Re: BP# 2016-02646_37 Fleetwood

Code Enforcement Officer /

Plan reviewer

Kitchen_Door_to_EntryWay.JPG

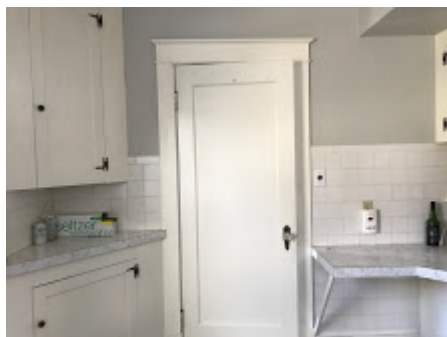
ii. One interior door (between kitchen and the abutting Mud Room) will be converted from swing to bi-fold. No (0) structural changes will be made to this doorway or its surrounding wall.

Wall_from_Kitchen2.JPG

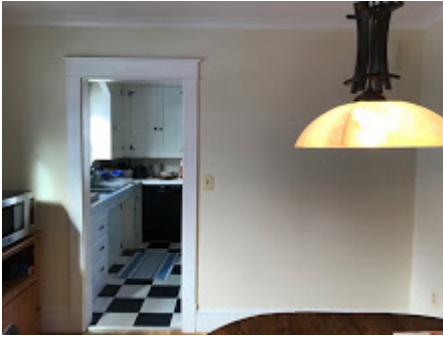
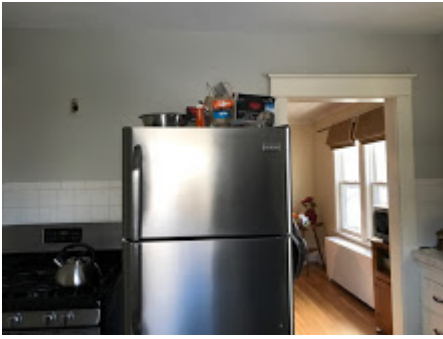
iii. The *sole* structural change to this home will be to one *interior* wall that divides the kitchen and dining room. This wall contains a doorway. This opening (the doorway) will be extended on one side, at the top (at eye level), to increase visibility between the two rooms. An LVL beam will be inserted above this opening to serve as a header to carry the load.

2. Please provide framing details of any new walls going in as well as the connection and support of the new LVL beam. Also, supply the specification of the new LVL beam.

Framing- Replace supporting wall with two 9 1/2" LVLs spanning approximately 10'. LVL's will be screwed together with high strength GRK fasteners and posted with 3 2*4 KD on both sides of the

beam. The posts will sit directly on the beam below (There is a beam in the basement under the wall which work is being performed on). When framing, work is completed the beam and wall will be covered with ½" sheetrock.
